# Rezoning Transportation Analysis

Petition Number: 2023-011

General Location Identifier: 04521224, 04521223

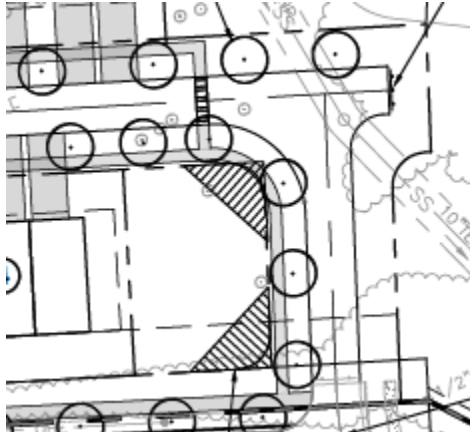
**5. ~~Add a conditional note specifying "A Right of Way Encroachment Agreement is required for the installation of any non-standard item(s) (irrigation systems, decorative concrete pavement, brick~~**

pavers, etc.) within a proposed/existing City maintained street right of way by a private individual, group, business, or homeowner's/business association. An encroachment agreement must be approved by CDOT prior to construction/installation. Contact CDOT for additional information concerning cost, submittal, and liability insurance coverage requirements."

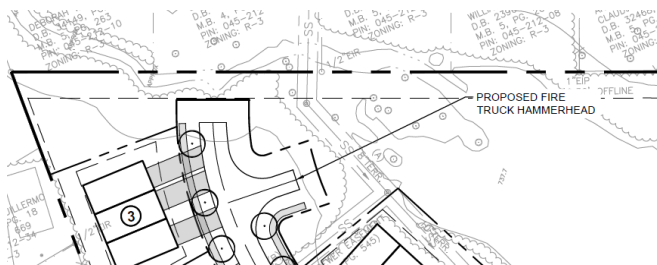
6. ~~Revise site plan and conditional note(s) to commit to streetscape along both sides of all proposed roadways.~~
